METROPOLITAN GOVERNMENT OF NASHVILLE AND DAVIDSON COUNTY

STAFF RECOMMENDATION
1812 Boscobel Street
June 19, 2013

Application: New construction—Infill
District: Lockeland Springs-East End Neighborhood Conservation Zoning Overlay
Council District: 06
Map and Parcel Number: 08314032600
Applicant: William Wood, Synergy Development Group
Project Lead: Melissa Baldock, melissa.baldock@nashville.gov

Left Side Elevation

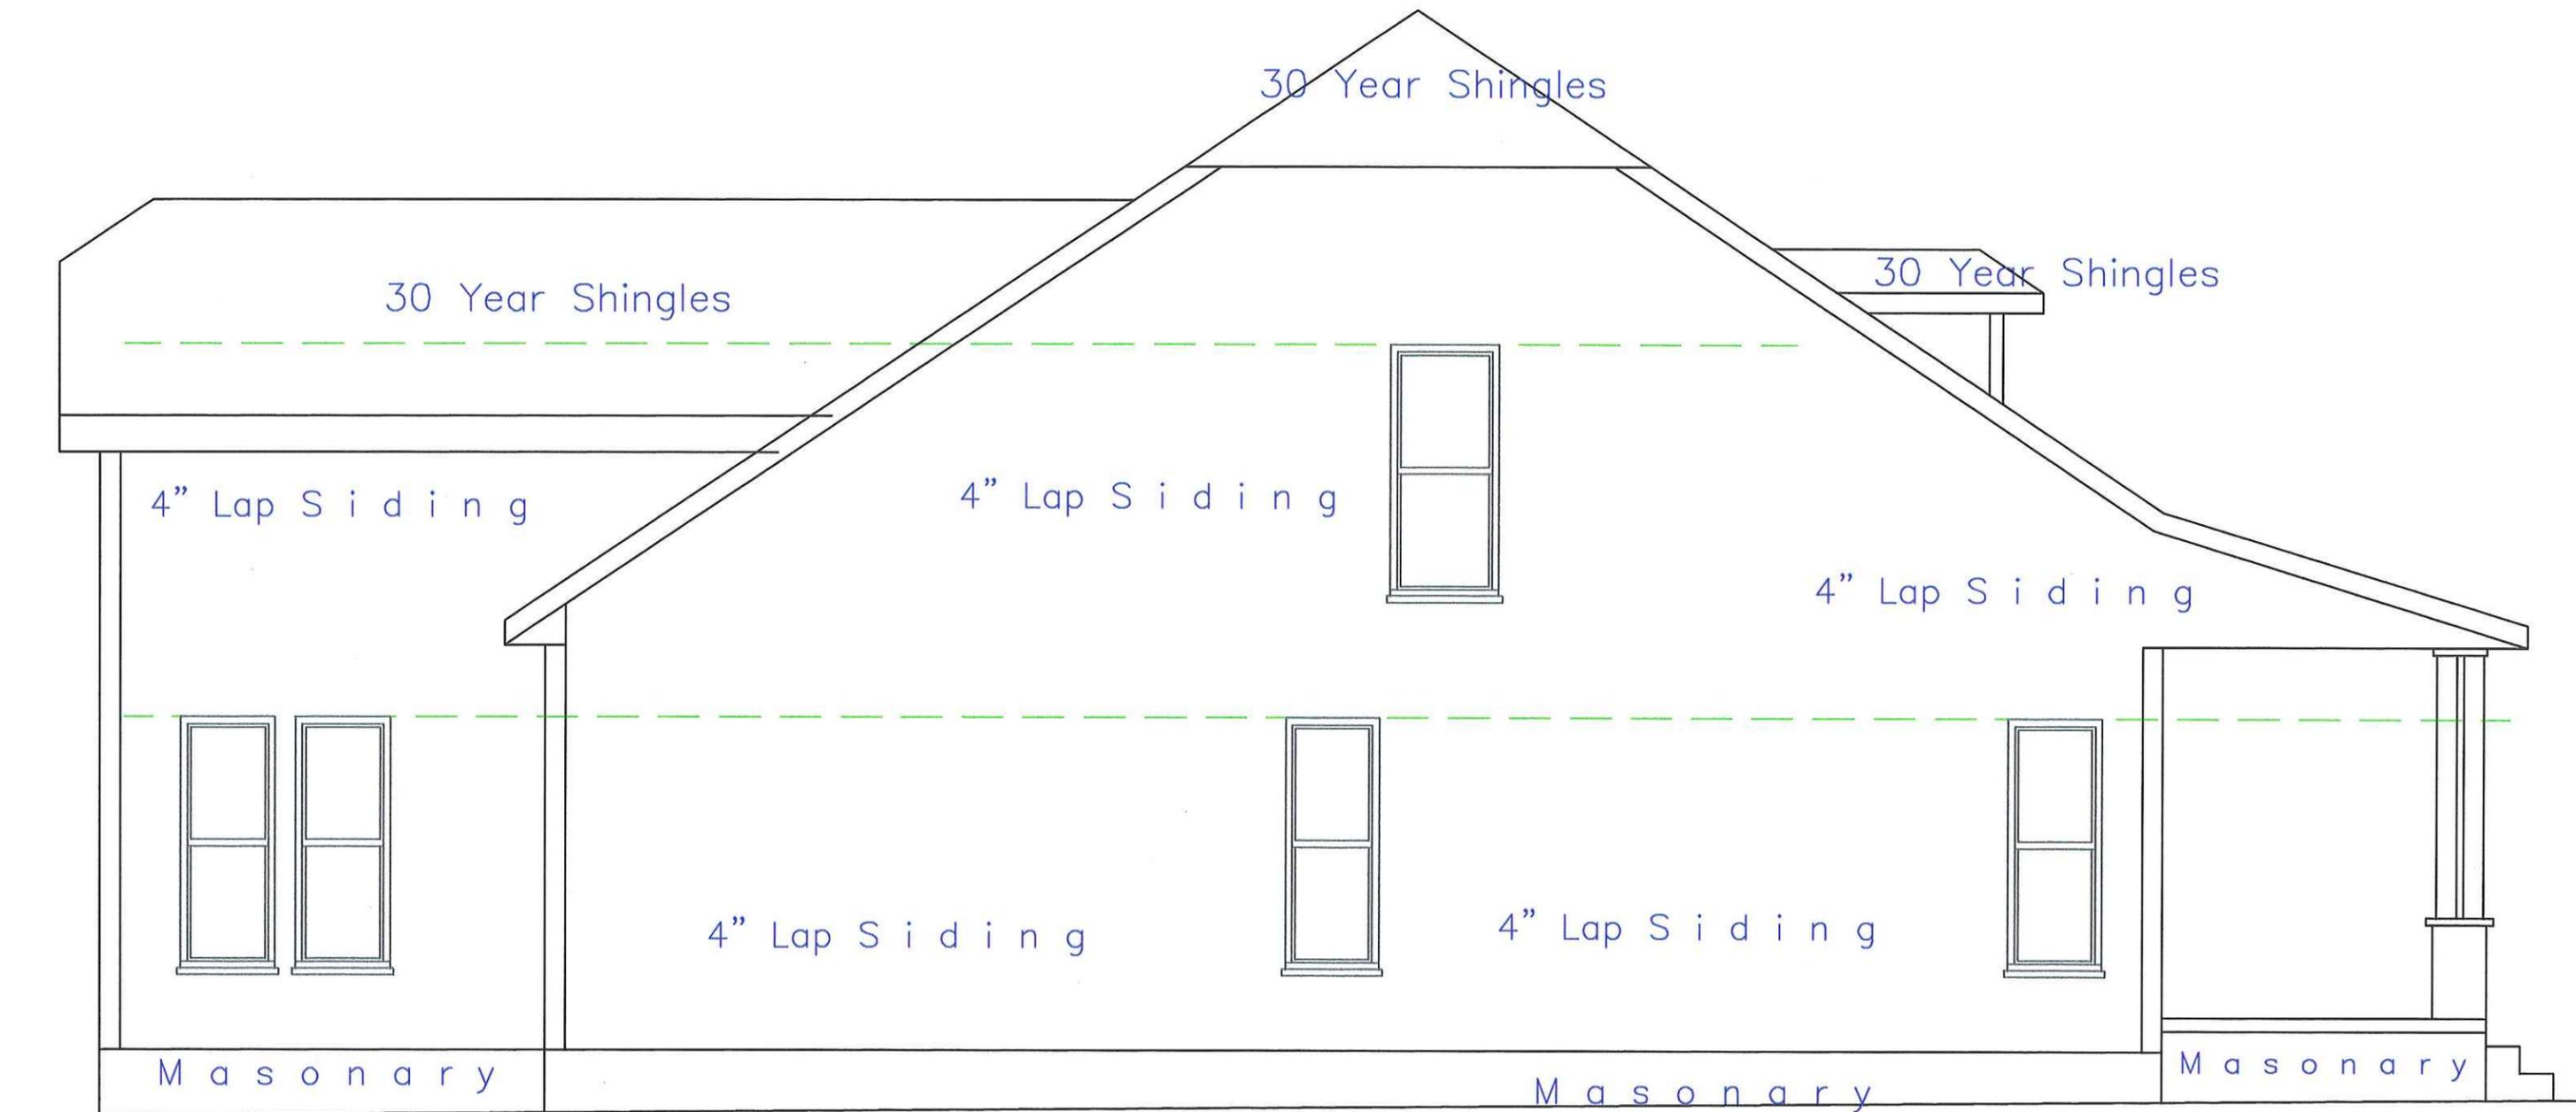
Staff notes that the drawings do not show a door frame around the front door, and asks that one be included. Likewise, the double windows on the front, rear, and left side elevations should have a frame around the pairs and a four to six inch (4"-6") mullion in between the windows. Staff also suggests that adding a band board on the side façades at the change in floor level will help break up the façade. Finally, staff asks that the front porch columns have a more substantial cap.

Proportion and Rhythm of Openings: The windows of the proposed structure are approximately twice as tall as they are wide, with the exception of some more utilitarian windows on the side and rear facades. The windows therefore meet the historic ratio of windows in the neighborhood. Both the right and the left facades have wall spaces of approximately seventeen feet (17') without a door or window opening. Staff finds that these expanses are appropriate in this instance because they occur on the side facades, towards the rear of the structure. Staff finds that the window proportions and rhythm of openings meet Section II.B.7. of *Lockeland Springs-East End Neighborhood Conservation Zoning Overlay Handbook and Design Guidelines*.
